**CITY OF ALBUQUERQUE
PLANNING DEPARTMENT
September 5, 2007
DRB Comments**

PROJECT # 1006783 APPLICATION # 07-70218

RE: Lot B-1, Rozzi/sketch

**Development Review Board 9/5/07 Agenda Item #23
Sketch Plat: Lot B-1, Rozzi Subdivision**

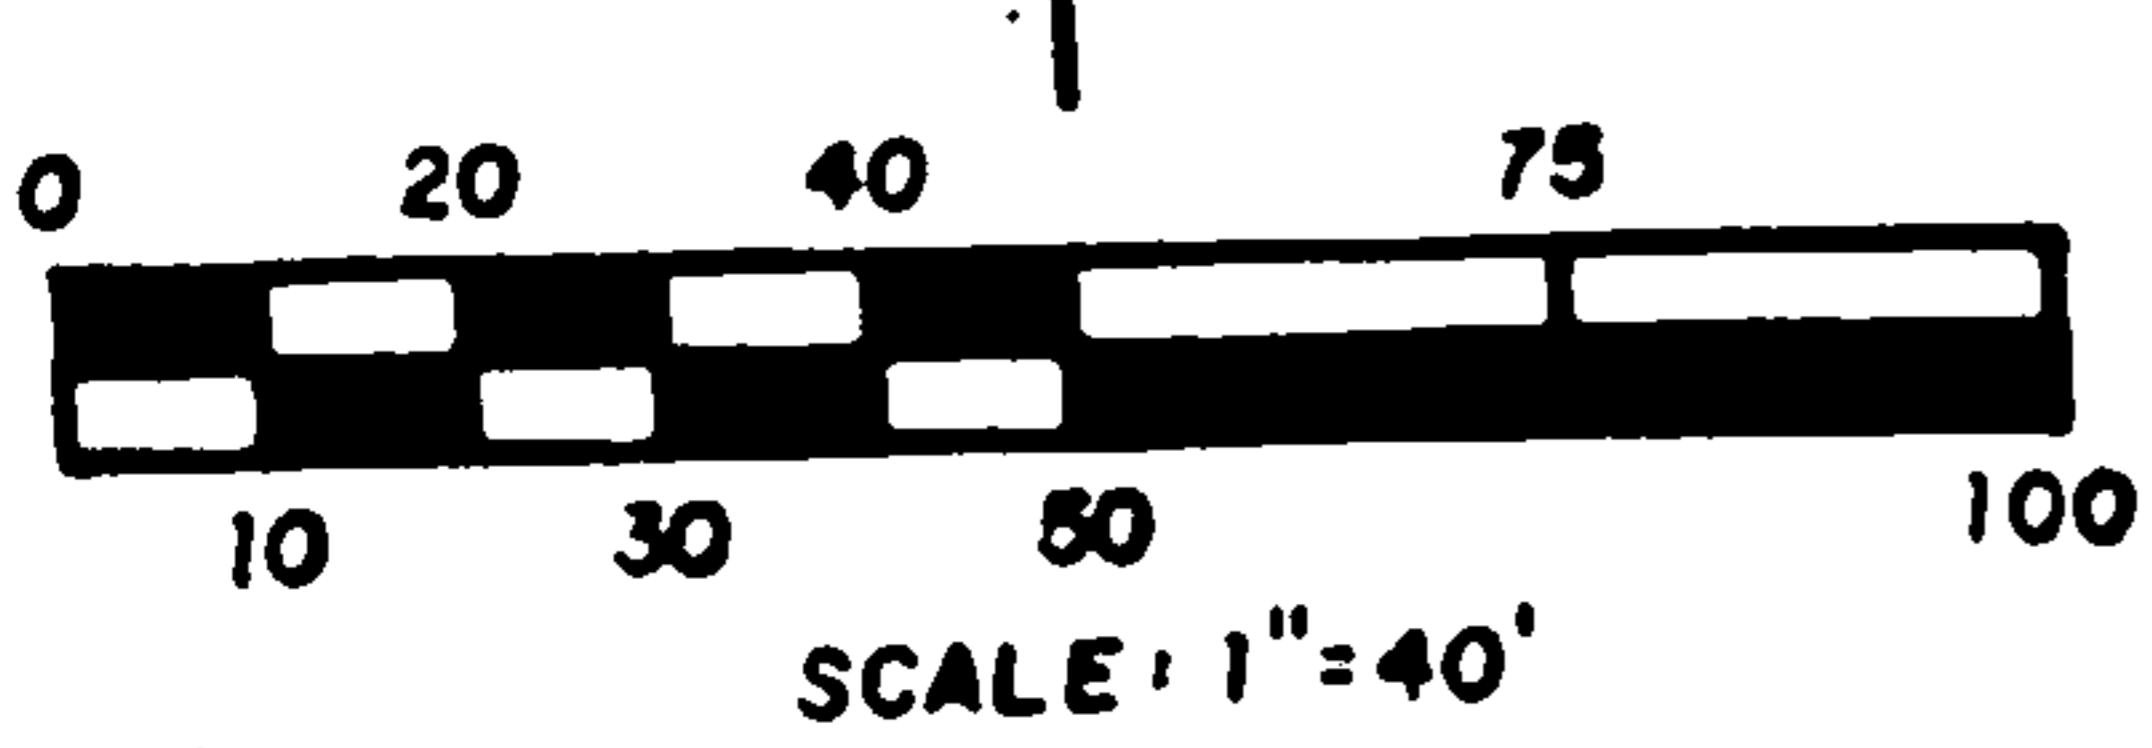
The new lot created at the rear of the existing one must have at least 5,000 square feet without counting the square footage of the proposed 15 foot access easement.

In addition, with the creation of the access easement, the 10 foot setback is required for the existing Rael home. It doesn't appear that the right side yard setback is met in the sketch.

The same setback requirements apply to the home adjacent to the Rael home because of the roadway easement.

- 1) A cross-sections of Mountain Road is needed to evaluate both dedication and infrastructure requirements. (Are there sidewalks?)
- 2) Standard infrastructure is required per the DPM.
